Application by Rosefield Energyfarm Limited for the Rosefield Solar Farm

The Examining Authority's first written questions and requests for information (ExQ1): issued on 2 April 2026

Comments by East Claydon Parish Council

Cable and Grid Connection Method

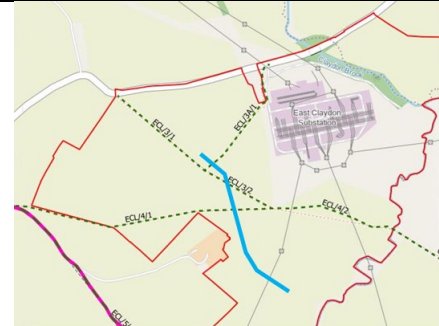
Fig. 2.1 clearly anticipates a cable connection to the proposed replacement National Grid substation. We would ask what surveys has the applicant undertaken in Fields SA51-53 in order to establish the impact of that cable route?
